Access Compliance Report

Public Rights-of-Way

(Curb Ramps)

Intersection ID: 22920	Main Street: HAMILTON_MILL_RD	Cross Street: PROVIDENCE_RD	Location: SW
ADA ID: 998F2A9EBA95	Ramp Type: Perp	Initial Pass/Fail: Fail	Overall Compliance: No
			Severity Score: 13.75

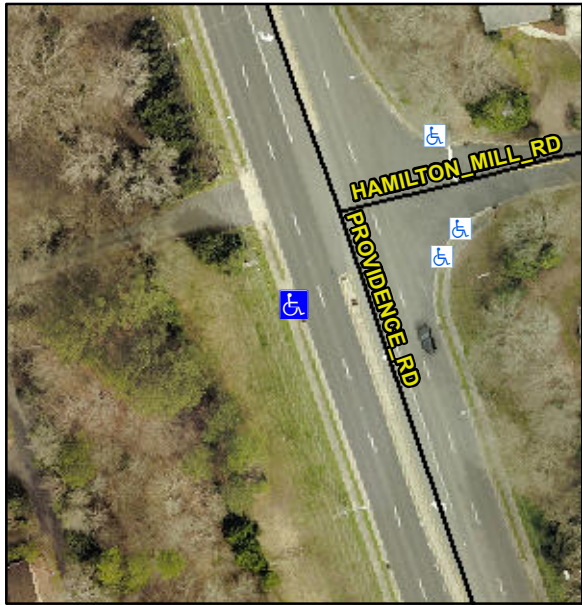
Codes/Mitigation Info/Possible Solution			Field Measurements/Component Compliance					
	Possible Solutions:		Compliance	Description	Data	Compliance	Description	Data
	Remove & Replace Entire Ramp.		N/A	Ramp Length (in)	73.0	No	Ramp Slope (%)	10.0
			Yes	Ramp Width (in)	53.0	Yes	Ramp XSlope (%)	4.0
			N/A	Flare Type LT	N/A	N/A	Flare Type RT	N/A
			N/A	Flare Slope LT (%)	N/A	N/A	Flare Slope RT (%)	N/A
			N/A	Flare Traversable LT?	N/A	N/A	Flare Traversable RT?	N/A
			N/A	Landing Length (in)	N/A	N/A	DWS Provided?	N/A
			N/A	Landing Width (in)	N/A	N/A	DWS Contrast?	N/A
			N/A	Landing Slope (%)	N/A	N/A	DWS Length (in)	N/A
			N/A	Landing X Slope (%)	N/A	N/A	DWS Full Width?	N/A
Surveyor Notes:	N/A		N/A	Landing Curb? (Y/N)	N/A	N/A	DWS Offset (in)	N/A
			N/A	Shared Landing?	N/A			
			N/A	Gutter Ponding?	N/A	N/A	Gutter Slope (%)	N/A
			N/A	Gutter Lip Ht (in)	N/A	N/A	Gutter X Slope (%)	N/A
			N/A	Painted X Walk1?	No	N/A	Painted X Walk2?	N/A

X Walk 1 Direction	To E		X Walk 2 Direction	N/A
			N/A	X Walk 1 Width (in)	N/A	N/A	X Walk 2 Width (in)	N/A
				X Walk 1 Slope (%)	1.3		X Walk 2 Slope (%)	N/A
				X Walk 1 X Slope (%)	4.3		X Walk 2 X Slope (%)	N/A
			N/A	Ramp inside XWalk1?	N/A	N/A	Ramp inside XWalk2?	N/A
PROW/ADA:	R304.2.2			Road Slope (%)	N/A	N/A	Clear Space?	N/A
				Road X Slope (%)	N/A	N/A	Clear Space to XWalk (in)	N/A
			N/A	Any Obstructions?	N/A	N/A	Storm Grate/Utility Hazard?	N/A
				Obstruction Type			Storm Grate/Utility Type	
						N/A		N/A
						Yes	Surface Condition? (G/P)	Good
	Total Cost:		\$	1850.00
